SUBJECT: SUMMARY OF CONFERENCE CALL WITH PALISADES NUCLEAR PLANT
REGARDING THE FALL 2010 STEAM GENERATOR INSPECTIONS
(TAC NO. ME4671)

CONFERENCE CALL SUMMARY
PALISADES NUCLEAR PLANT FALL 2010 (1R21) OUTAGE STEAM GENERATOR
INSPECTIONS

STEAM GENERATOR TUBE INSPECTION DISCUSSION DURING PALISADES 2010 (1R21) OUTAGE

Palisades Cycle 21 Primary to Secondary Leakage

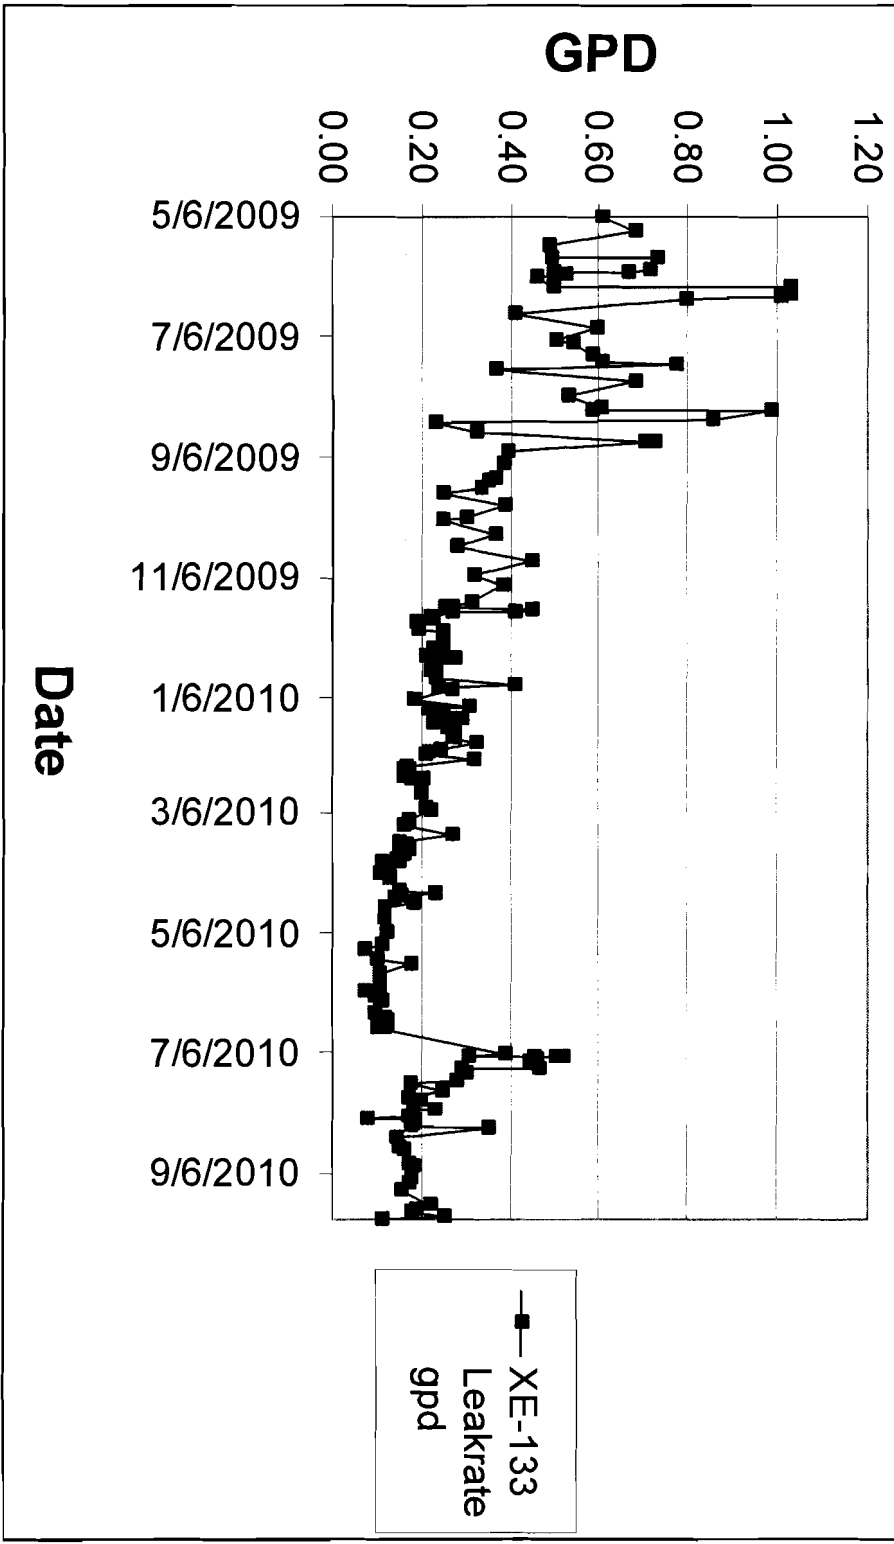
1. Discuss any trends in the amount of primary-to-secondary leakage observed during the recently completed cycle.

Refer to attached Primary to Secondary Leak Rate for Operational Cycle 21 Primary to Secondary Leak Rate graph. Leakage has been minimal all cycle.
